# United States Patent and Trademark Office

APPLICATION NO.	FILING DATE	FIRST NAMED INVENTOR	ATTORNEY DOCKET NO.	CONFIRMATION NO
10/776,784	02/11/2004	Manfred Eichenauer	2426.35US01	3227
7590 12/29/2005			EXAMINER	
Douglas J. Christensen			LUGO, CARLOS	
	ente, Skaar & Christens er, 80 South Eighth Str		ART UNIT	PAPER NUMBER
Minneapolis, MN 55402			3676

#### **DETAILED ACTION**

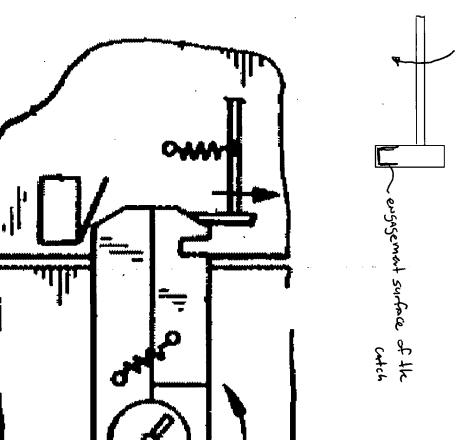
engagement surfaces of the catch are provided on a lateral side of the catch in the direction of its latching pivotization (see attachment #1).

The applicant argues that Kletzmaier fails to disclose the new limitation presented in claim 1 that the engagement surfaces of the catch are provided on a lateral side of the catch in the direction of its latching pivotization. However, as seen in attachment #1, Kletzmaier clearly illustrates that the engagement surfaces of the catch are provided on a lateral side of the catch in the direction of its latching pivotization. Therefore, the argument is not persuasive and the rejection is maintained.

pivotal movement to later the eatch
